STATE OF MAINE
DEPARTMENT OF TRANSPORTATION
16 STATE HOUSE STATION
AUGUSTA, MAINE 04333-0016

December 29, 2022
Subject: Acadia Gateway
State WIN: 017163.03
Location: Trenton
Amendment No. 3

ACADIA GATEWAY FACILITY

INTERMODAL AND WELCOME CENTER

DOOR AND LOUVER SCHEDULES

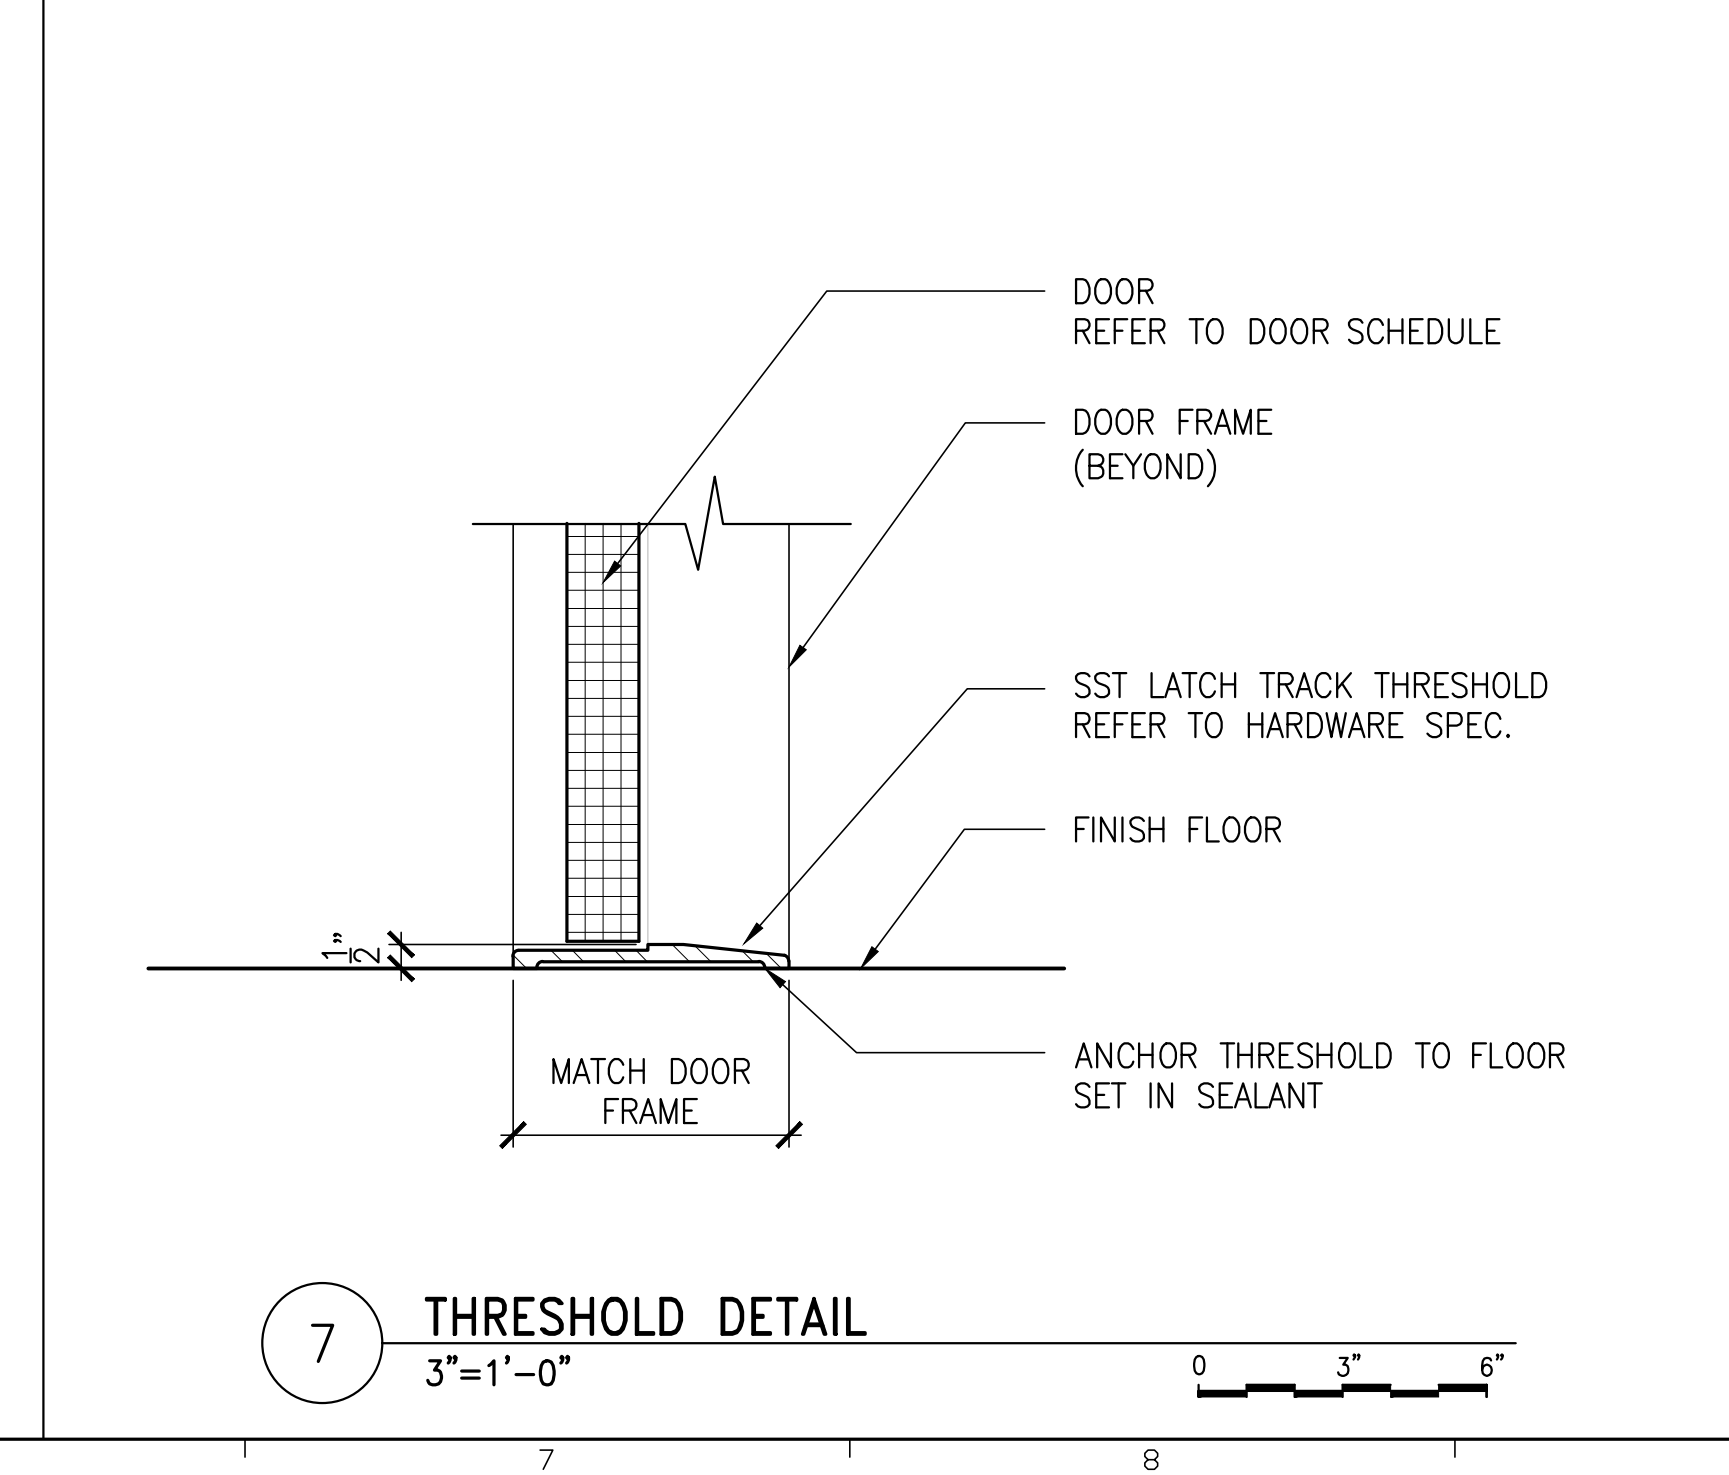
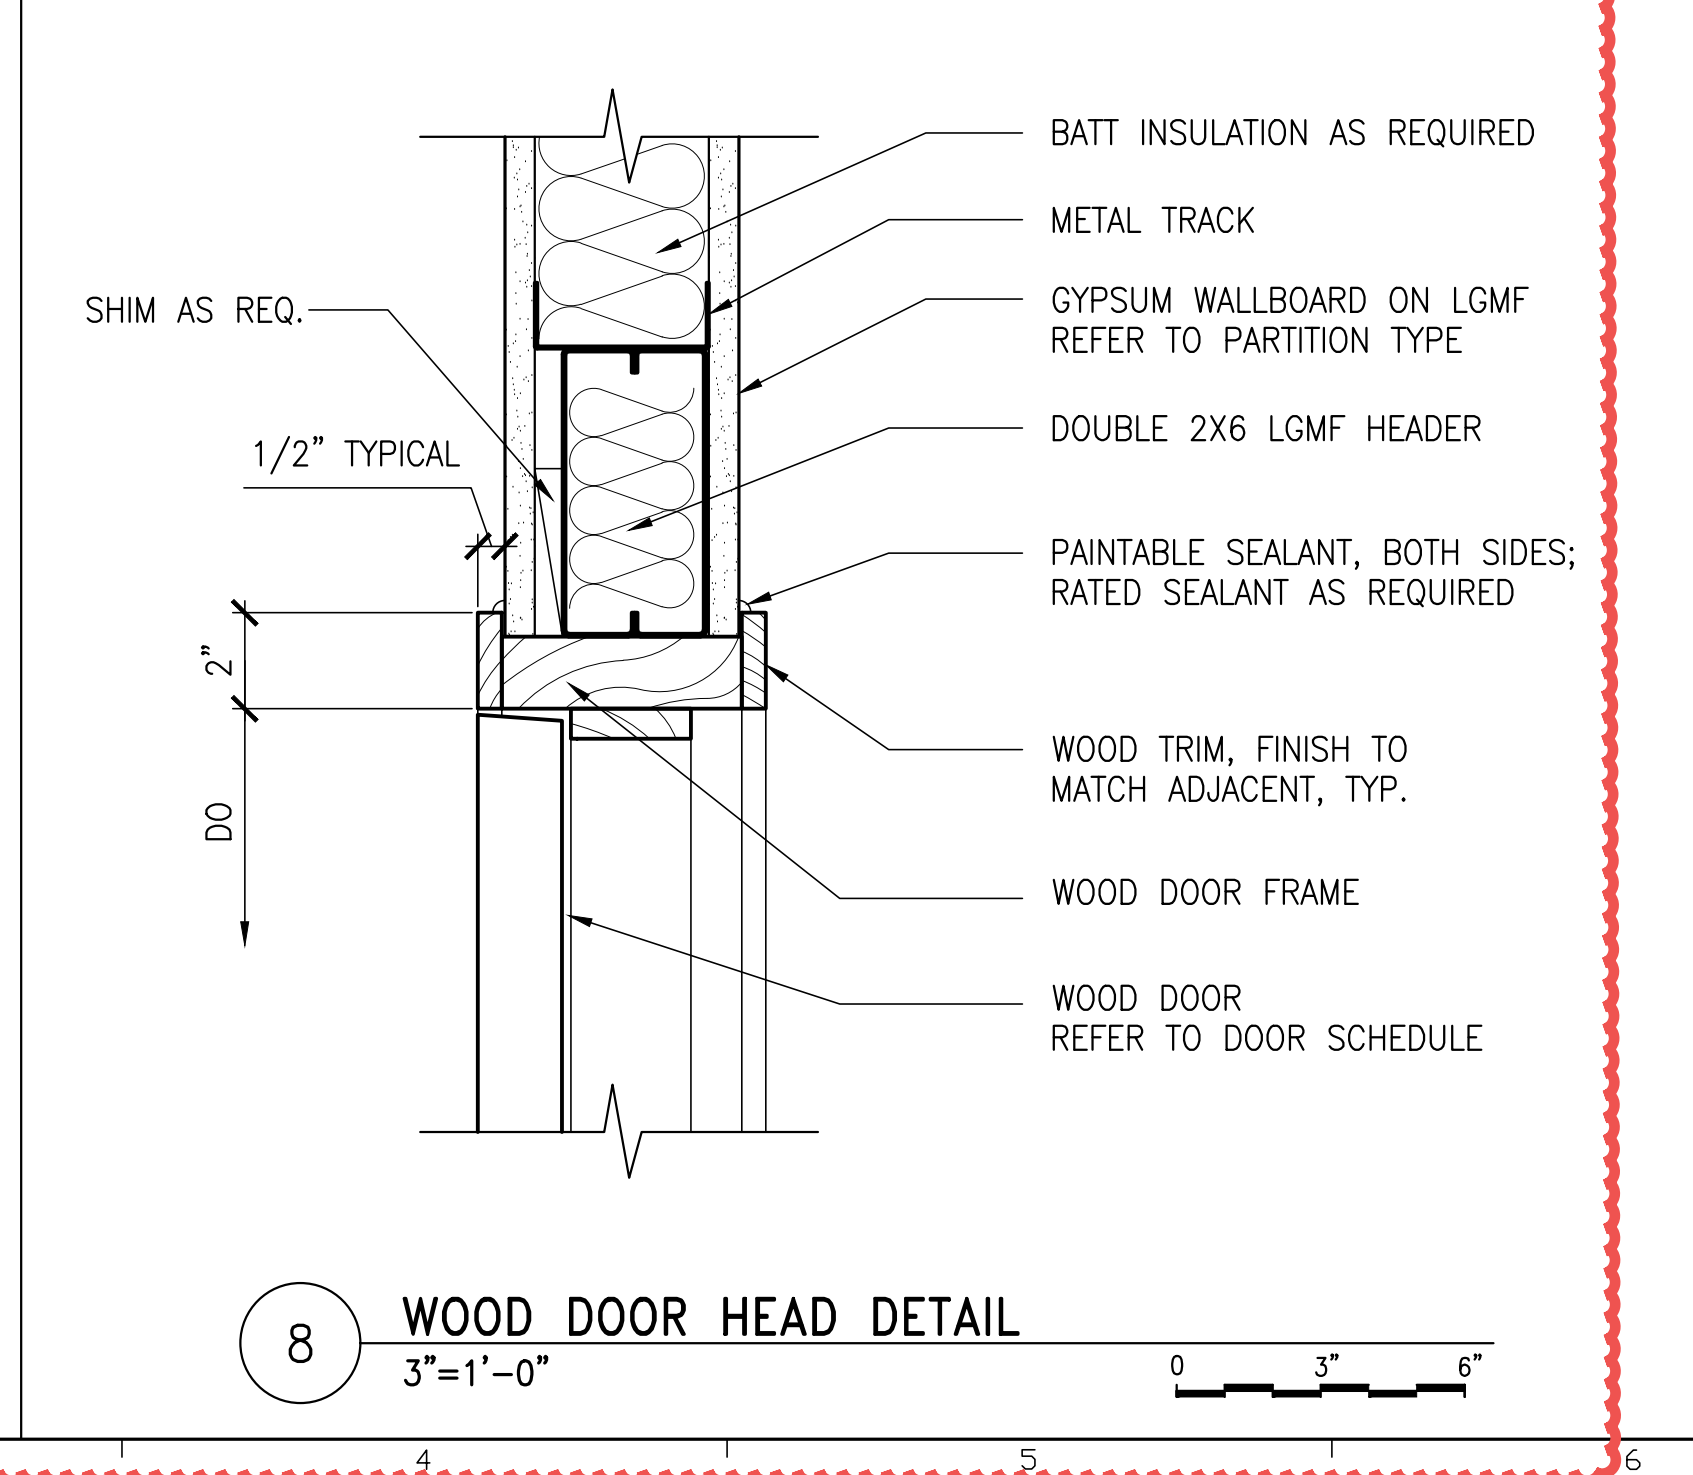
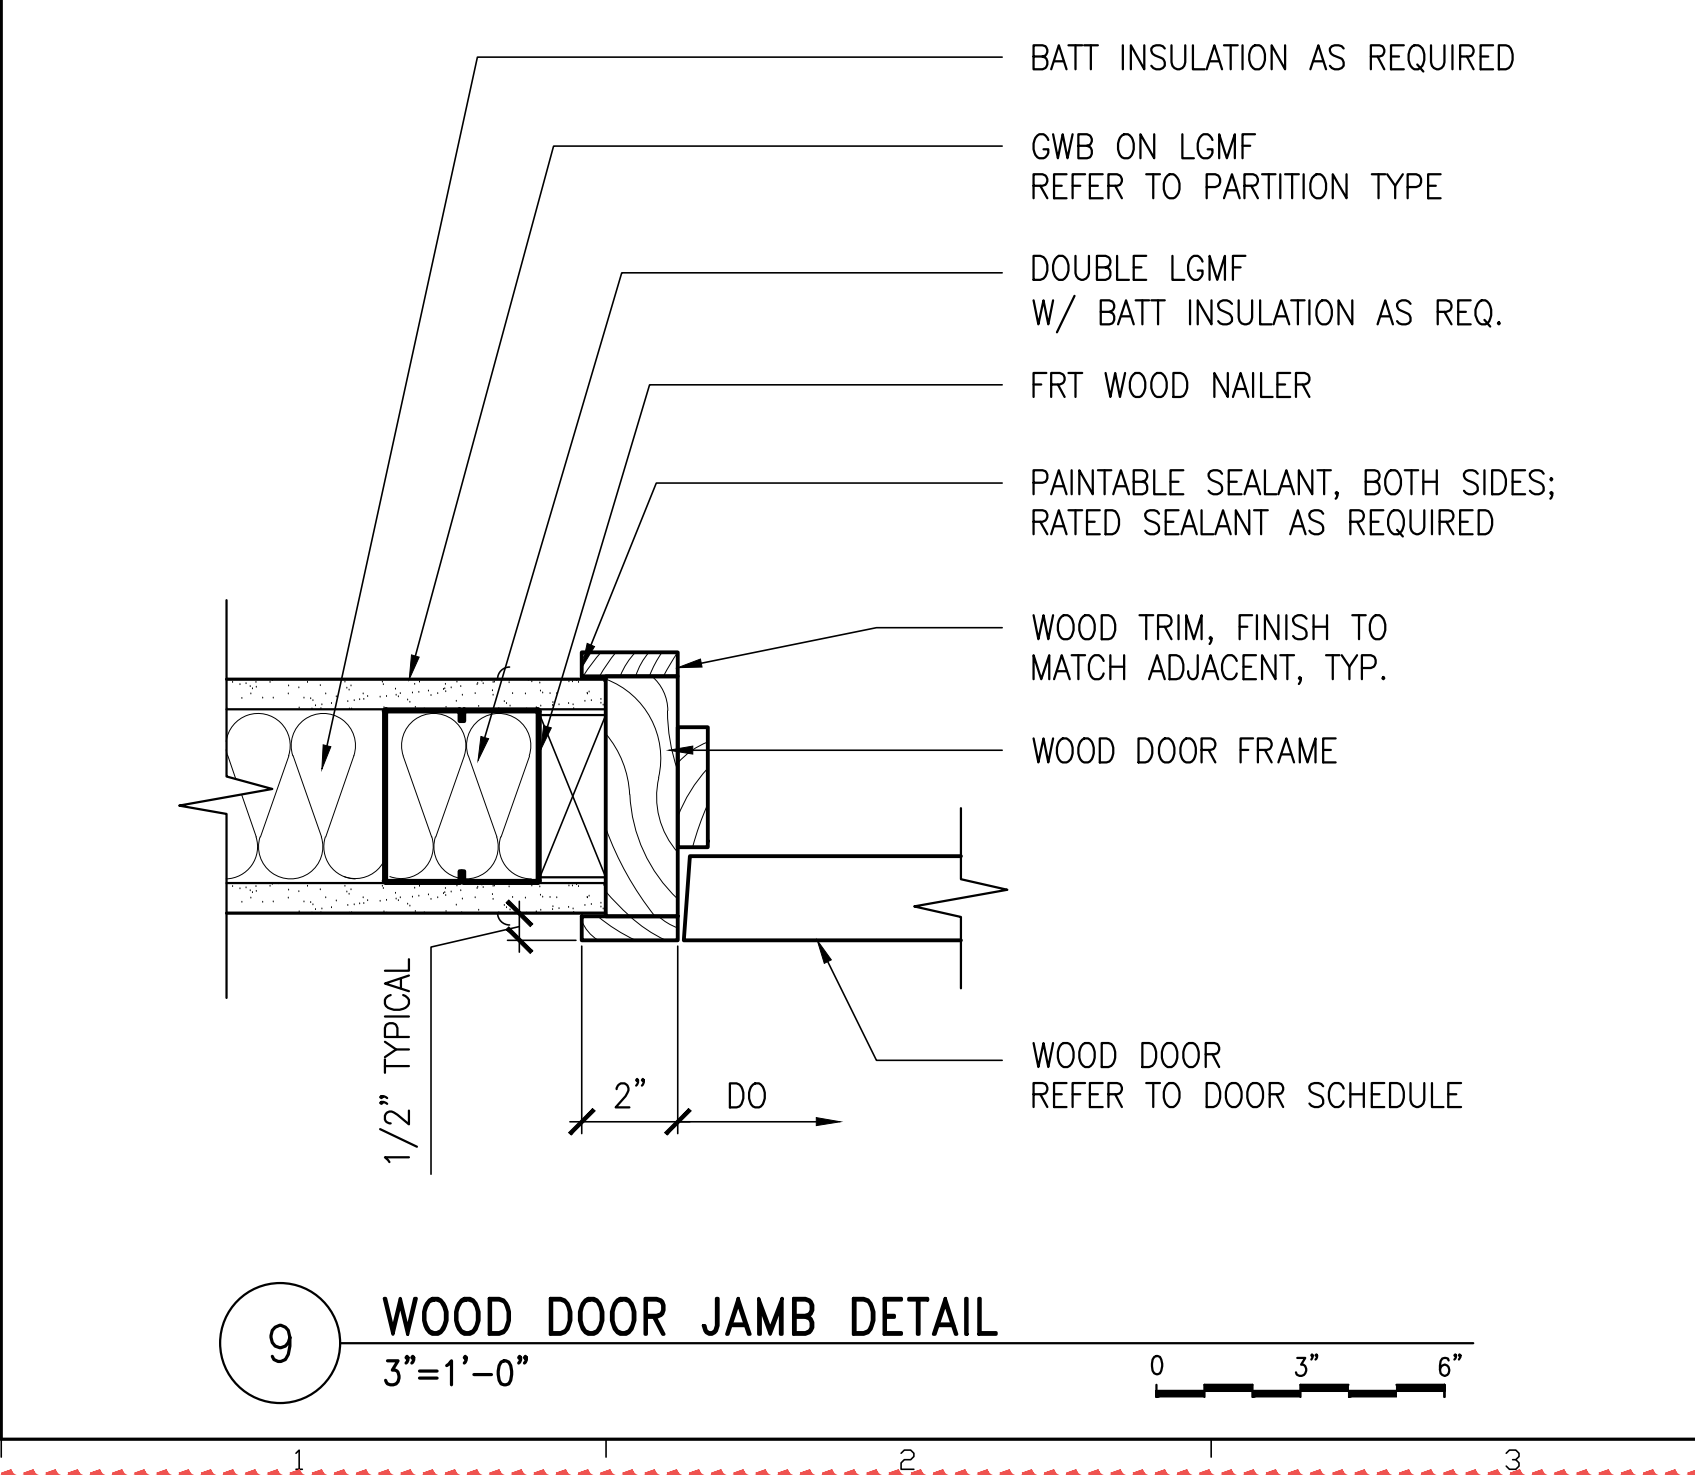
Question: Doors 125B and 125C – Please confirm these should be Steel Frames by Hope (Door Schedule calls for Steel Doors x HM Frames)G

Response: Doors 125B and 125C should have steel frames. Drawing A802 - Door Schedule has been updated as part of Amendment #3.
